**Application Ref. DC/19/04650
EXECUTIVE SUMMARY
REVIEW OF PLANNING APPLICATION LANDSCAPE DRAWINGS
for
Chilton Parish Council and Lady Hart of Chilton
relating to the Anderson Group Site at
Land off Waldingfield Road, Chilton, Sudbury**

17th December 2019

Application Ref. DC/19/04650
REVIEW OF PLANNING APPLICATION LANDSCAPE DRAWINGS
for
Chilton Parish Council and Lady Hart of Chilton
relating to the Anderson Group Site at
Land off Waldingfield Road, Chilton, Sudbury

Existing parkland boundary vegetation along Waldingfield Road

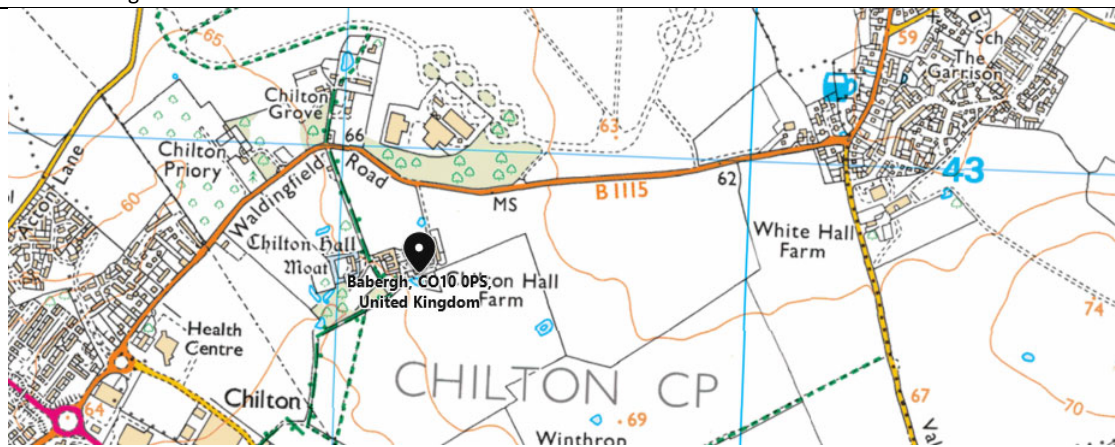
- 2.2 **The Existing RPG Tree Boundary:** The existing mature trees along Waldingfield Road at the edge of the Registered Park and Garden of Chilton Hall are tall and attenuated, with the majority of branch development in the top canopy area, with several large gaps between trees. Shrubs are relatively small and the combined planting offers little in screening value, relative to the 9m high ridge lines of proposed development. Currently the site hoarding gated entrance is visible from within the parkland.

The site hoarding is clearly visible behind trees and shrubs bordering the RPG parkland boundary along Waldingfield Road

4.0 JBA drawings Ref. JBA 19-144-01 Rev H, Detailed Proposals Ref. JBA drg 19-144-12 Rev F, 19-144-13 Rev F and Plant Schedule, Ref. JBA 19-144-14 Rev F

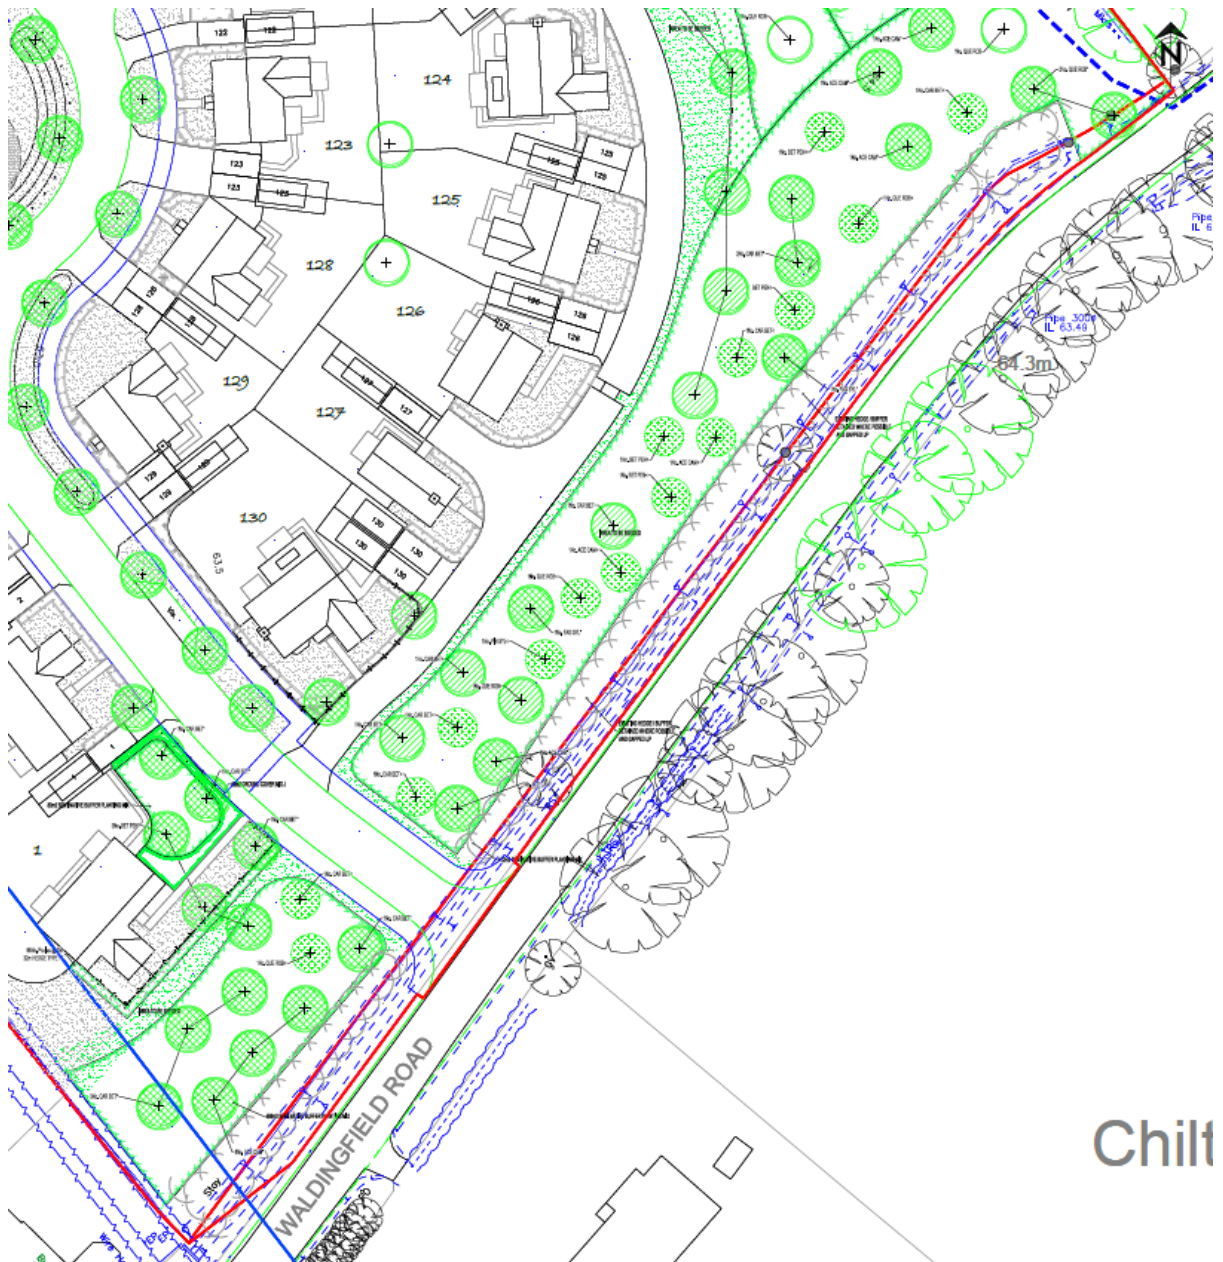
- 4.1 Insufficient depth of screen planting. A landscape buffer of 20m minimum depth all along the site frontage is achievable within the site layout and would not require a major layout review to accommodate this. CPC suggested this at the recent site meeting to ensure at least 5 rows of trees could be accommodated within the buffer planting. This was to be measured from the inside base of the existing hedge on the site side, as the hedgerow is thin with a lack of screening value. The JBA masterplan suggests a wide and thick hedge along the site boundary, which is very misleading, with additional 'width' only at the canopy tips. The total width of planting perpendicular to the road, to include the existing hedge is approximately **11.5m-15m maximum width**, opposite key plots 1, 130 to 125. This is significantly narrower than the 20m width requested for most of the plot frontage landscape, to provide the landscape buffer in addition to the narrow, existing hedge.

- 4.2 It should be noted, planting depths are inaccurately reported in the JBA 'Landscape and Visual Mitigation Measures', dated 14th November and Planning Committee Report P101 as being between **14m-21m**, with an **average of 19m depth**, assuming this includes the hedge, incorrectly indicated as 5m wide.

- 4.3 Depth of planting is inadequate. The revised detailed layout JBA drg 13 Rev F (below) indicates planting extended by an average of 5m. This is not significant in the overall

- scheme, when a minimum 20m depth of new planting was requested behind the existing hedge and only a maximum of **11.5m-15m has actually been provided.**

- 4.4 This additional 5m extension only provides 4-5 rows of shrubs at 1/m², with only 10 additional trees indicated in the whole of this buffer opposite key plot 1 and plots 125, 126, 127 and 130. **It is a fact that a single tree canopy, or even 3 tree canopies combined, will NOT create a robust network of branches in winter to filter and block views** of the proposed 9m high linear rooflines associated with this development. This can only be achieved by greater multiples of layered tree canopies; but these require sufficient space to develop as a linear woodland with a shrub understorey. The number of trees required would depend on species.

- 4.5 Approximately half the trees proposed are indicated as larger stock, but tree densities are low, in a single staggered row of canopies one tree deep opposite these key plots and 3no canopies to the front of plot 1 and 130. Shrubs will never reach 9m in height, with an average of 5m at maturity. **Even when mature, this tree planting scheme will fail to provide a closed woodland screen at canopy level during winter months, as viewed from Chilton Hall and the RPG.**

- 4.6 Significantly more trees and rows of tree are required in lieu of shrub planting.
- 4.7 JBA drawing 13 Rev F detailed proposal planting depths are actually as follows:

- The landscape buffer at the centre of the site opposite Chilton Hall and the key plots is at its narrowest at **10.5m** wide and **14.5m wide** at its widest point, plus the width of the existing narrow hedge, shown incorrectly as a dense linear feature 5m wide. Trees are proposed generally as a single staggered row, widening towards Chilton Priory where more space permits greater depth of planting.

- 4.8 When the current JBA plan is compared with the approved outline permission EDP Landscape Strategy, (above), tree numbers are significantly lower, as the approved drawing EDP shows multiple layering of canopies on a grid, that will combine to create a dense screen, with a minimum of 3no rows of trees indicated along the whole length of the southern boundary. JBA has not adopted the matrix planting system to achieve a similar level of screening value.

- 4.9 **Proposed tree canopies need to be layered in multiples, with a minimum of 5no new tree rows, not 1no or occasionally 3no trees deep as currently proposed to the front of critical plots 1, 130, 127, 126 125 and 124.** These new canopies will also need to combine with existing parkland trees at Chilton Hall to create a more effective screen. The maximum number of tree canopies currently located between the development site and moated garden, based on JBA drg 13 rev F is either 2 or 4no tree canopies. This is not adequate to provide an impermeable buffer to screen new housing and

4.10 Tree quantities in the JBA Rev F layout below are:

- Based on an assumed site boundary length/distance of 149m x average buffer width of 13.25m = 1,974m² total area, with **48no proposed trees**, which is an increase of 10no, compared with the original JBA scheme.

Original Section EE showing a 100 year old Oak tree (not lime as specified)

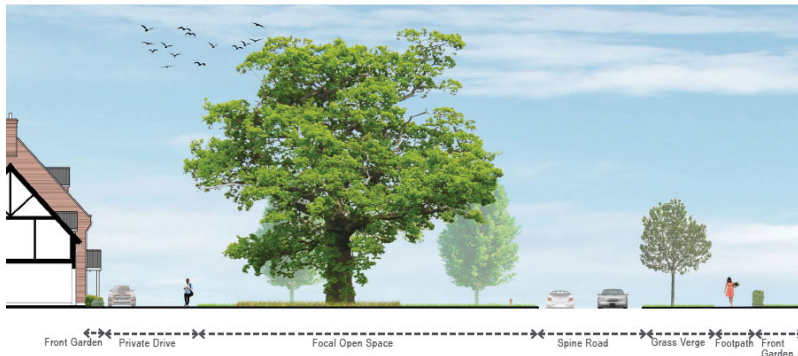
5.1 JBA Site Sections not updated. It was accepted that the original sections submitted were significantly exaggerated and very misleading, with a 100 year old mature oak tree illustrated as a new lime tree on Section E-E. Revised sections across the site have not been resubmitted.
